CONTRACT NO. 1797

OHIO RIVER TUNNEL

ADDENDUM No. 8

All bidders bidding **Contract No. 1797** shall read and take note of this **Addendum No. 6**. The Contract Documents for **Contract No. 1797 – Ohio River Tunnel** are hereby revised and/or clarified as stated below.

ALLEGHENY COUNTY SANITARY AUTHORITY (ALCOSAN) OHIO RIVER TUNNEL (ORT)		Contract: 1797
ORT-ST-501 AS1 ACCESS SHAFT SUPPORT OF EXCAVATION - SHEET 2 OF 2		File: ORT-ST-501.dwg
		Date: 07/30/2025
		Sheet: 153 OF 770

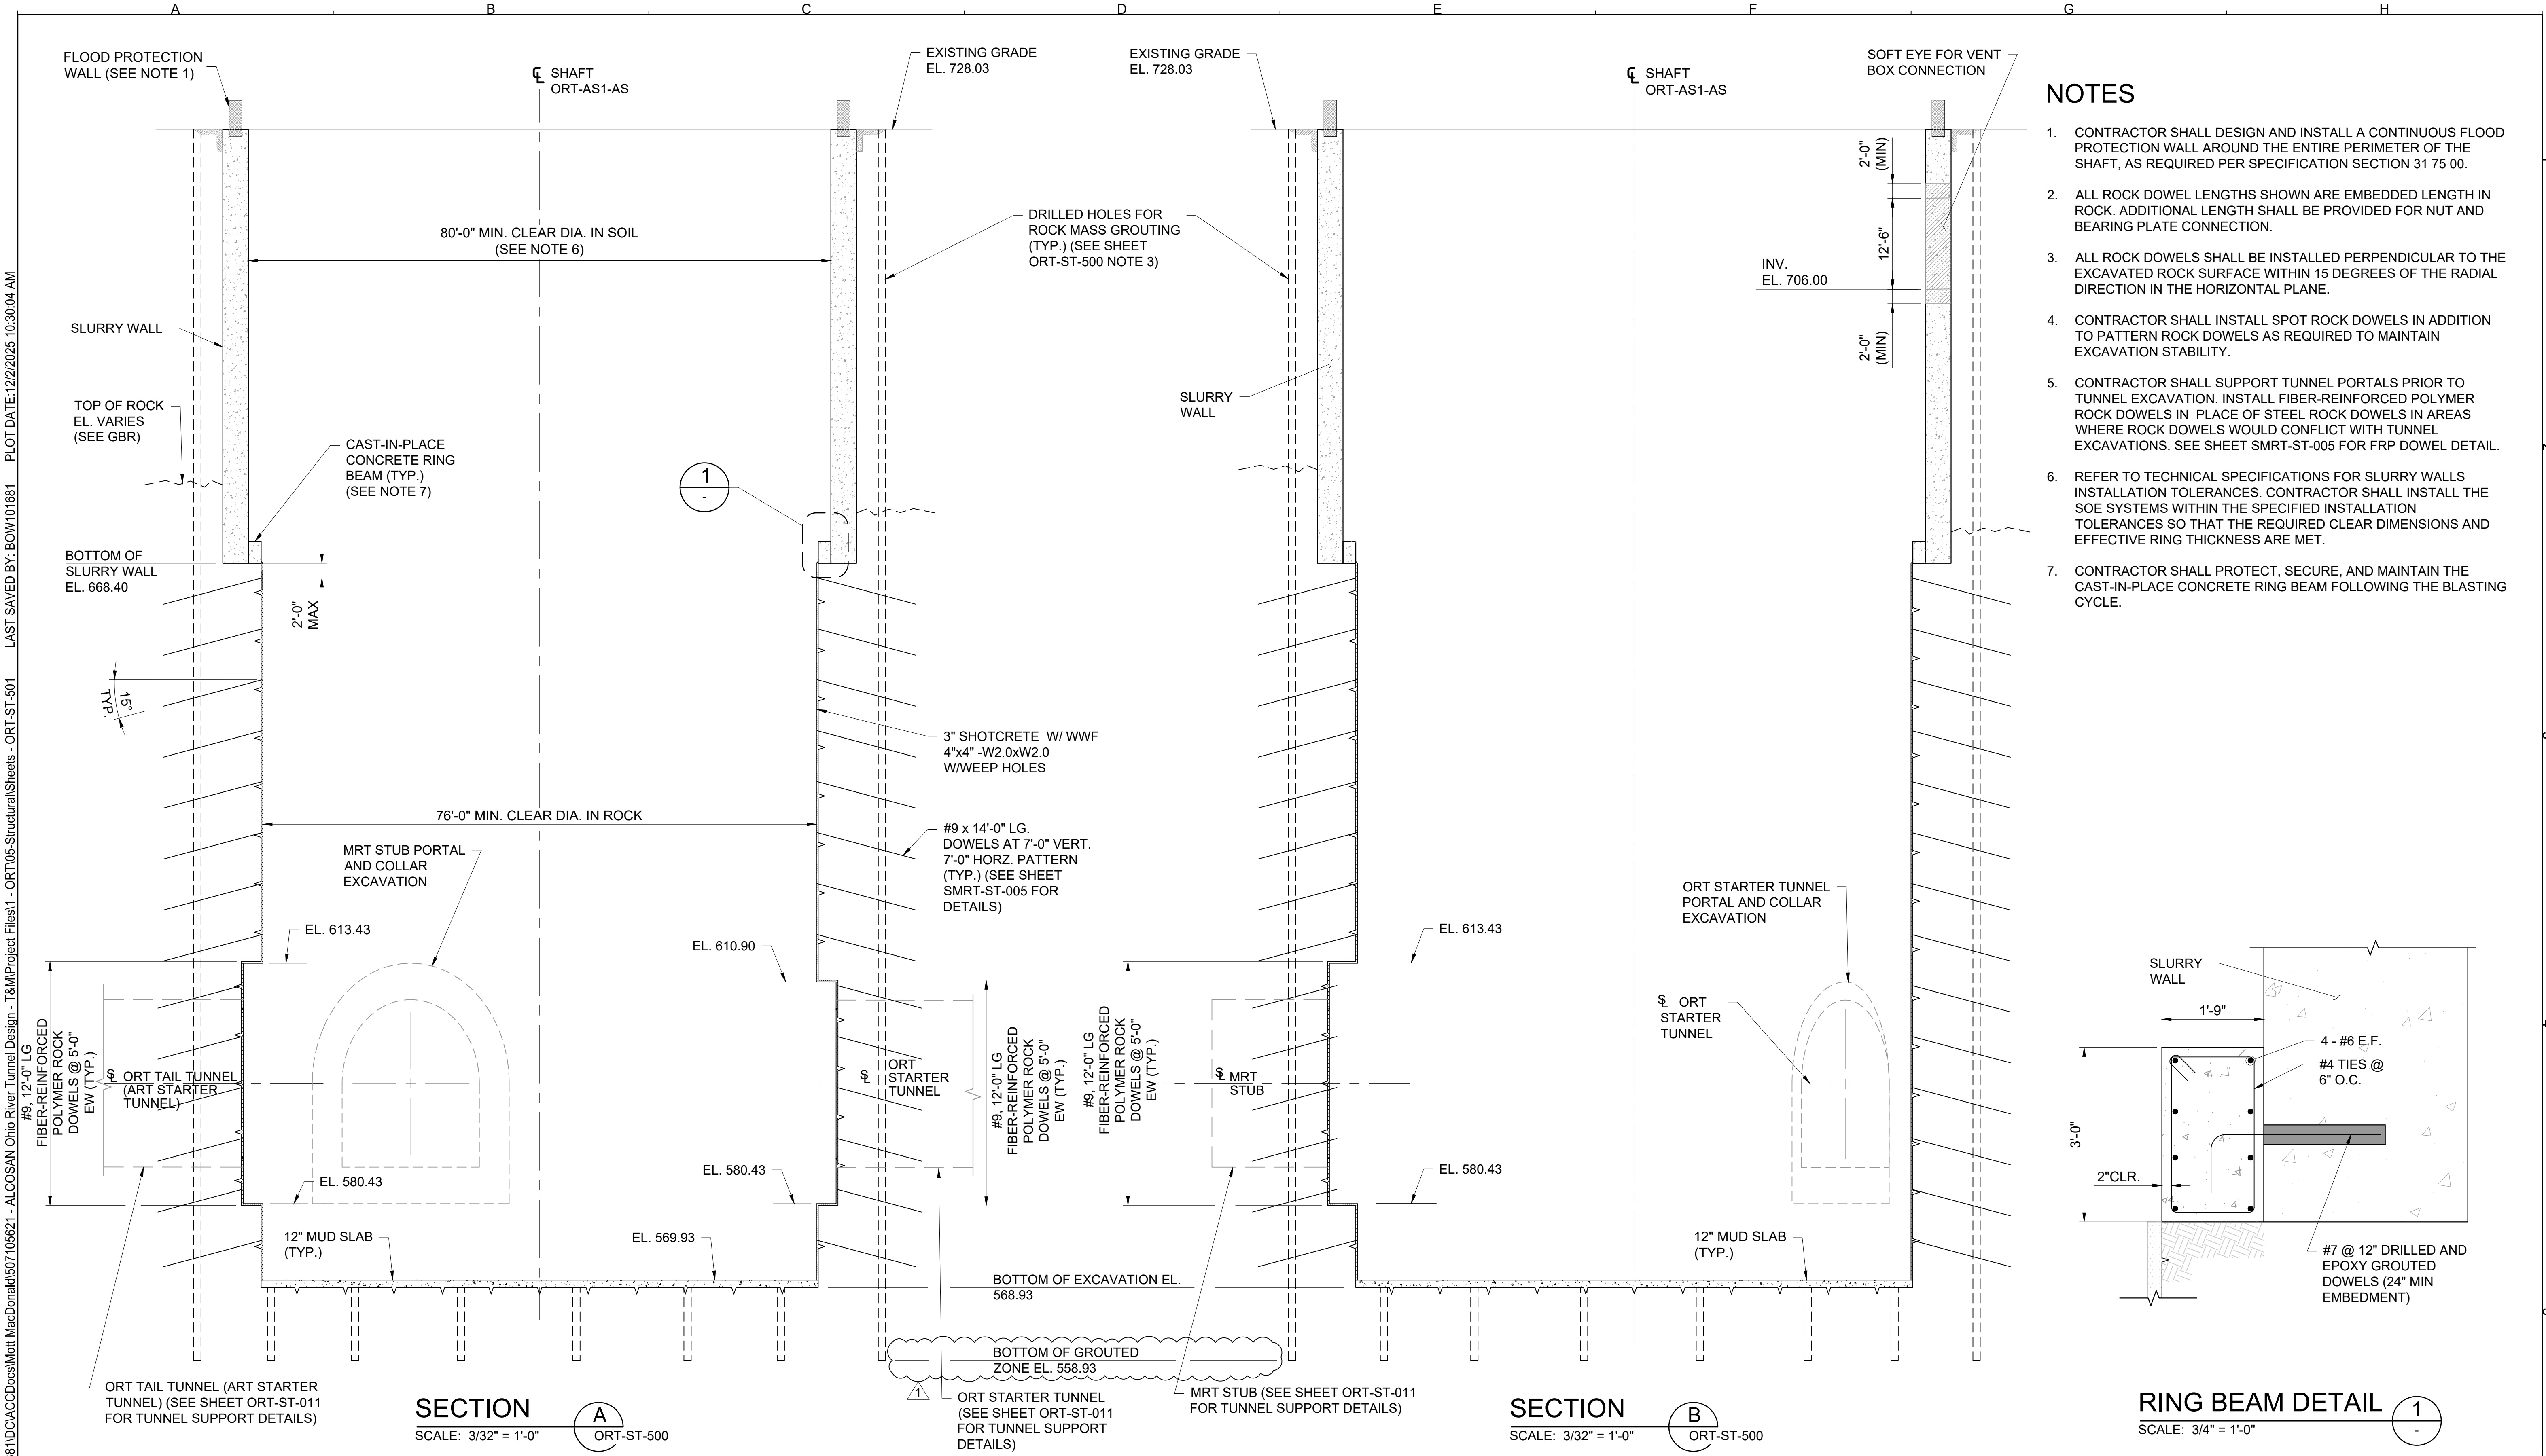
- A39 *Question – The drawing ORT-ST-501 for the AS1 shaft does not show a bottom elevation for the grouted zone. Please provide the required elevation of the bottom of the grouted zone.*

Sheet ORT-ST-501 has been REVISED to add the elevation.
- See Section B, Item 11 for **CHANGES TO CONTRACT DOCUMENTS** for revisions to **ORT-ST-501.**
- Q40 *Specification Section 01 50 00, AS1 Owner's Field Office - Specification 01 50 00, paragraph 1.1.C.3 notes that "the Owner's Field Office shall remain after Contractor demobilizes at the ORT-AS1 site."*
If Contractors cannot remove the field office when they demobilize from the site, please provide the number of calendar days from notice to proceed Contractors should expect to have this office on the AS1 site.

- a. DELETE ORT-ST-501 (Sheet 153 of 770) and ADD REVISED ORT-ST-501 (Sheet 153 of 770) which is Attachment A to this Addendum.
